Our Case Number: ABP-314724-22

Re: Railway (Metrolink - Estuary to Charlemont via Dublin Airport) Order [2022]
Metrolink. Estuary through Swords, Dublin Airport, Ballymun, Glasnevin and City Centre to
Charlemont, Co. Dublin

Hampstead Residents CLG

Metrolink Submission 22/11/2022. (Case number 314724)

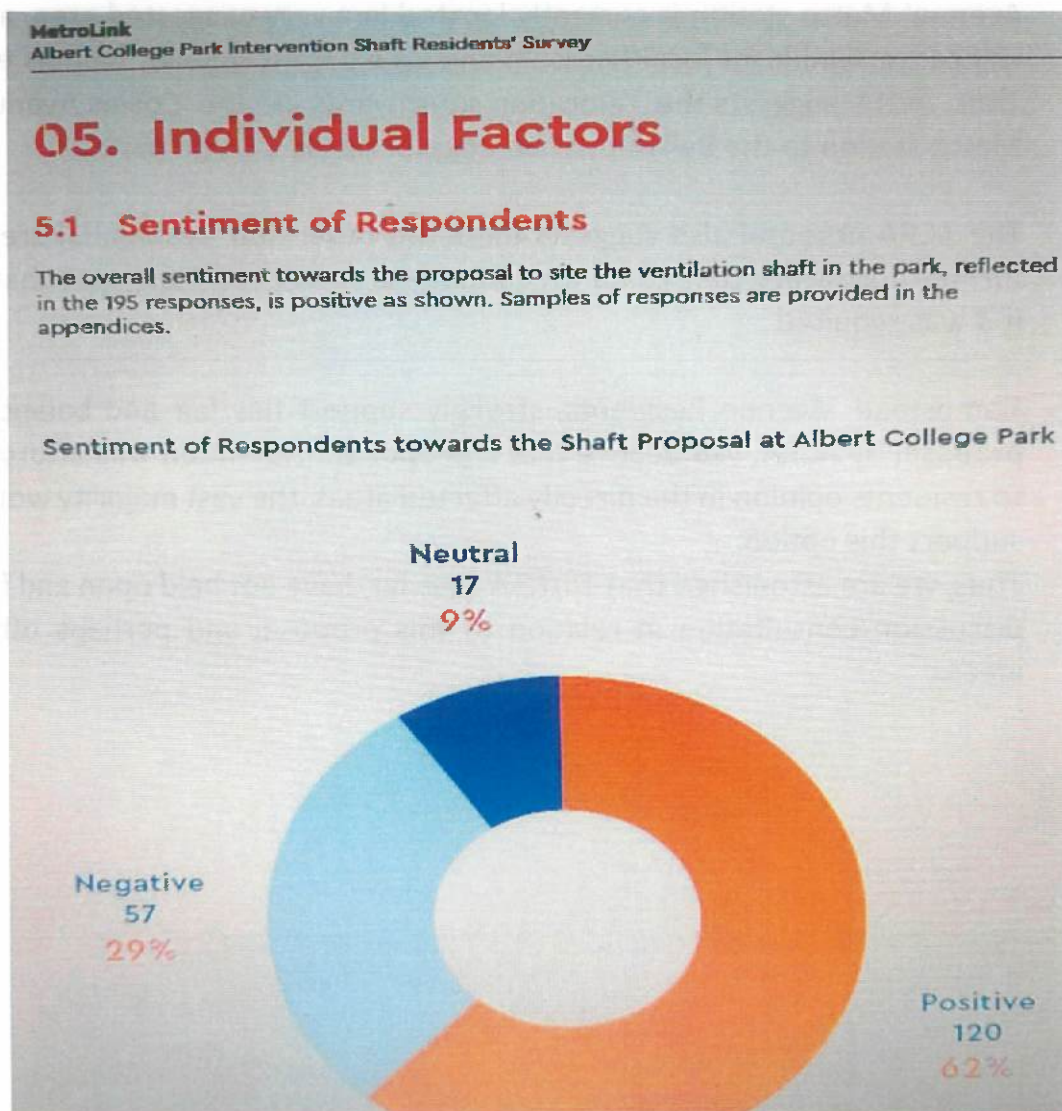
In these delivered 'leaflets'...residents were asked questions ONLY about the aesthetics/appearance, park amenity (construction phase) etc of the proposed Intervention shaft and NOT about any other potential options or ideas.

See Fig below:-

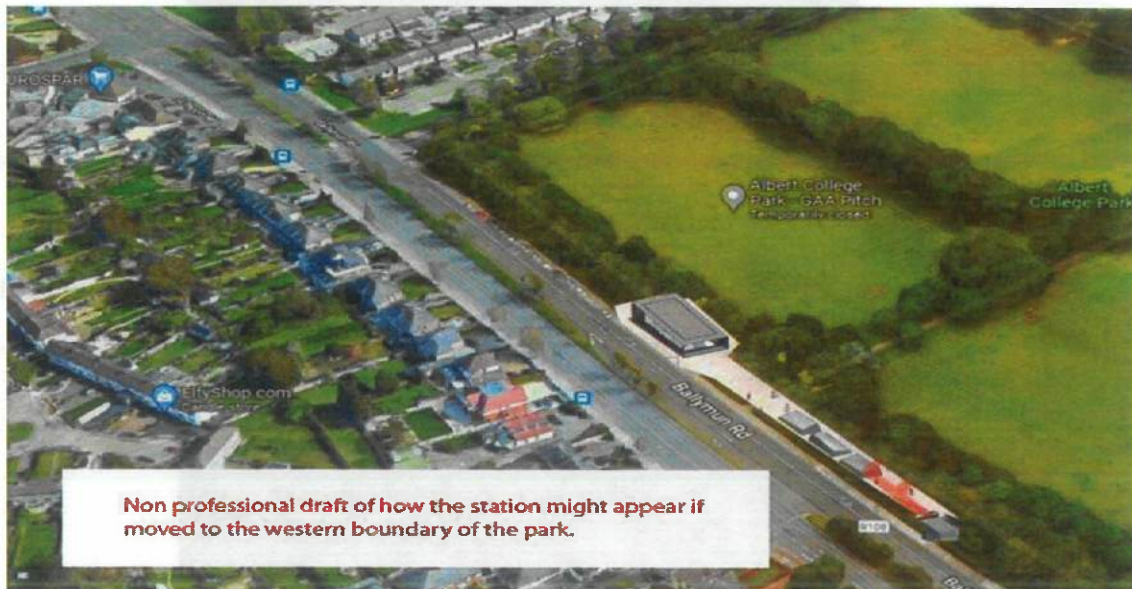
In the 'pie graph' below '5.1 Sentiments of Response', it states 'overall sentiment towards the proposal to site the ventilation in the park'. The TII/NTA seems to have taken the direct answers to their direct and leading questions (that were ONLY relating to an intervention shaft) as a 'positive response' to the intervention shaft itself. We strongly believe that this process was a total 'paper exercise', misleading, a sham, a waste of tax payers money, an insult to residents intellect, and certainly does not even get close to the meaning of the word Consultation!

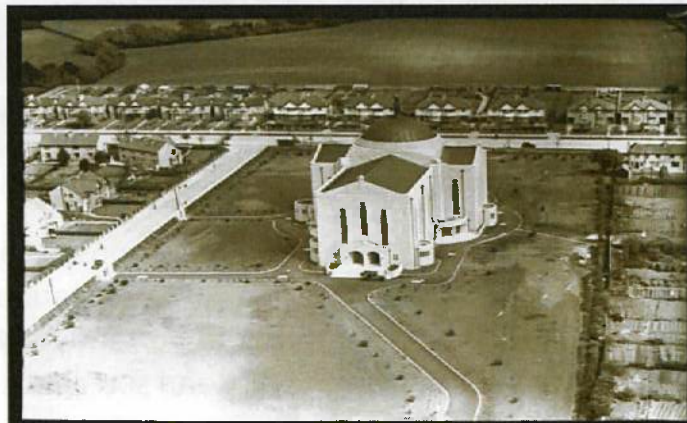
See Fig below:-

- b. Investigate the possibility to change the proposed Intervention shaft in Albert College Park for a Metro station. A Metro station will have the same function as an intervention shaft, but importantly it will be a high value 'transport amenity' for our community and surrounds. The presence of a local Metro station will future proof the area in anticipation of imminent development (example:- a nearby 10 acre development site at DCU lands in Eustace's Estate off Griffith Avenue.)

In Summary: A station would fulfil all of the safety criteria of the shaft, and would meet the zoning requirements, and would benefit the local area. Additionally we believe there is a clear and distinct lack of future planning here . eg:- If this 'proposed shaft' was made a station for future use. There is a precedent! – it could act in the manner of Dardistown to remain inactive until these sites are developed.

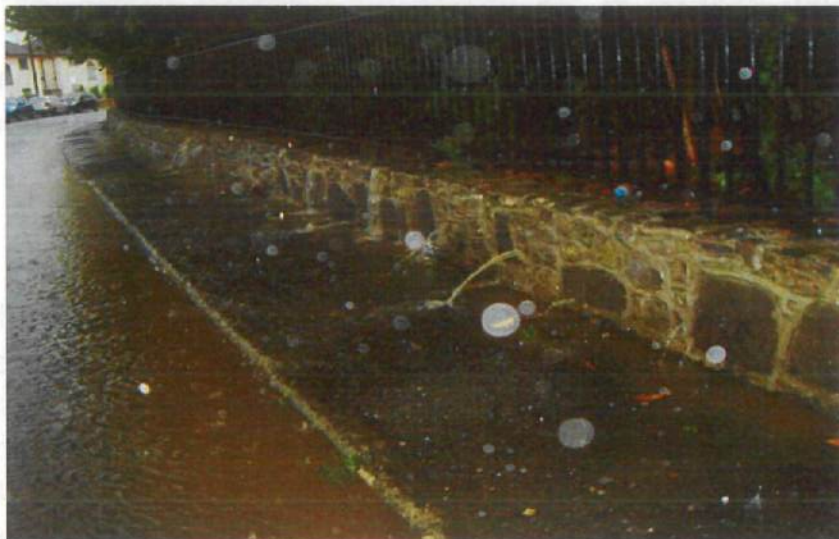
The picture below shows flood water from Albert College Park, pouring through the stone wall, flooding onto Hampstead Avenue.

R.O. condition Request 8: We believe the Inspector should request TII to include a condition in the R.O. detailed plans on how run-off water, or disturbed underground water (pools/streams/rivers), will be managed in the area as specified above, and in consideration of the serious flood risk to residential properties.
